Gilroy 2040 General Plan EIR

September 23, 2020

FINAL ENVIRONMENTAL IMPACT REPORT

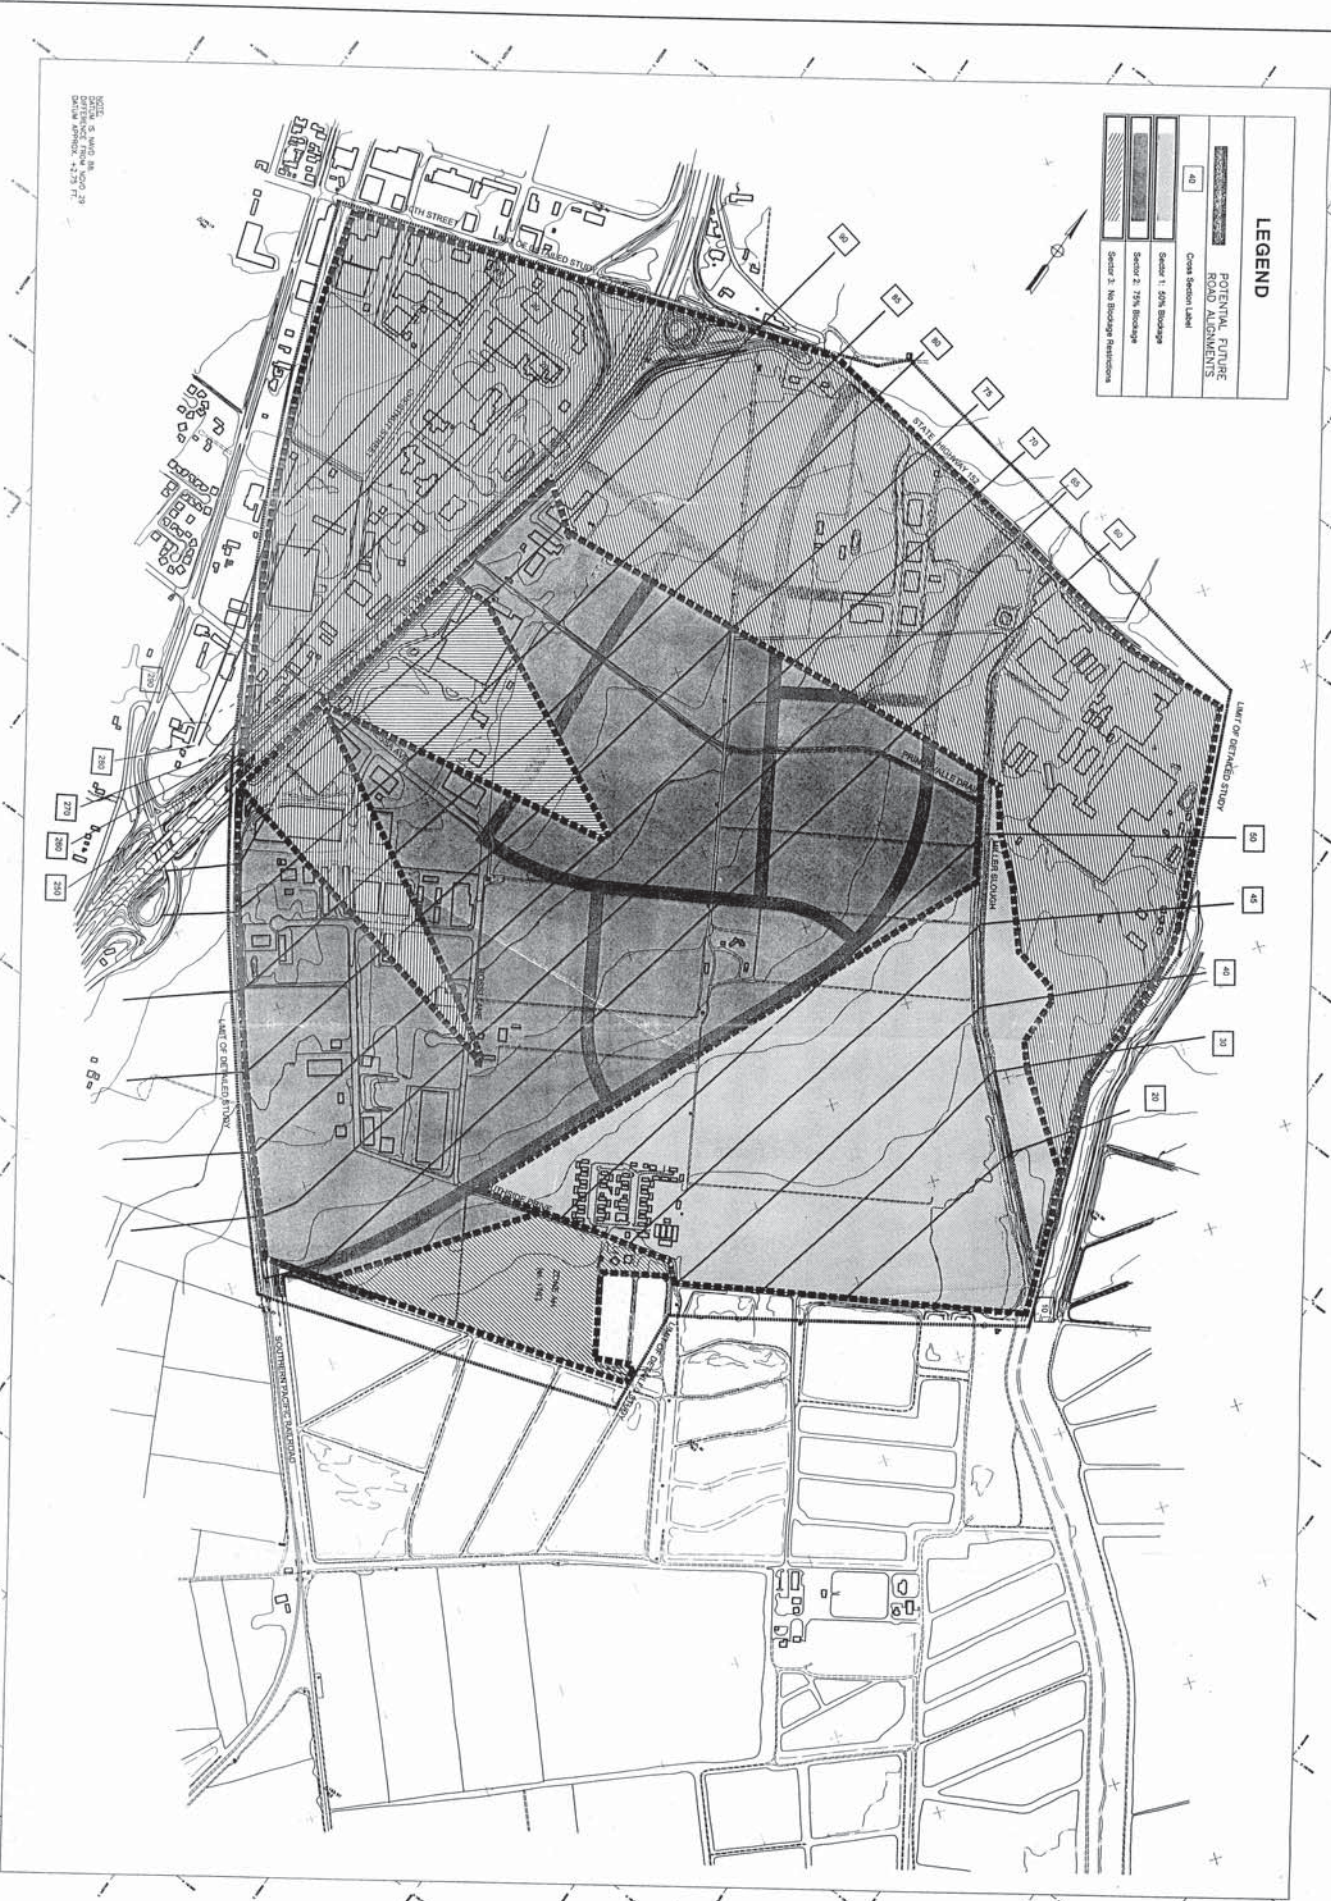
28. **Comment.** DEIR, Appendix C. Gilroy 2040 General Plan proposes a number of policies in regard to water conservation. Both Policy NCR 3.10 and PFS 3.8 promote achieving a 20 percent reduction in per-capita water use from 2009 levels by 2020 consistent with the State's 20x2020 Water Conservation Plan. Since 2020 has already arrived, Valley Water suggests that the policies be altered to more forward thinking and set further targets for future years. Some suggestions include adoption of New Development Standards, incorporation of Advanced Metering Infrastructure, and the promotion of Green Streets as part of Gilroy's stormwater collection (potentially as part of Goal PFS-5). Policy PFS 5.2 is a mitigation for Increased Storm Water Runoff. However, Valley Water believes that in order for PFS 5.2 to provide sufficient mitigation for increased storm runoff and mitigate the potential for increased flood risk, this policy must be amended to or another policy created to clarify that stormwater from new development or redevelopment and/or the provision of a storm collection system should be designed to not exceed the existing capacity of receiving creeks and channels. The current policy PFS 5.2 suggests that the storm collection system only needs to be designed to convey runoff to the receiving creek or channel with no provision to ensure that the receiving creek or channel can accept the runoff without adverse flooding impacts.

Response. For smaller projects in the areas of the unconfined Llagas sub-basin, the City will include a policy in the General Plan to encourage project design to maintain post project flows to be the same as pre-project flows. It should be noted, however, that the City's stormwater standards for Tier 3 projects indicate offsite discharge is

prohibited up to the 95th percentile storm event, for Tier 2 projects treat and release is allowed, and Tier 1 projects allow a more passive design 'best practices' to minimize runoff.
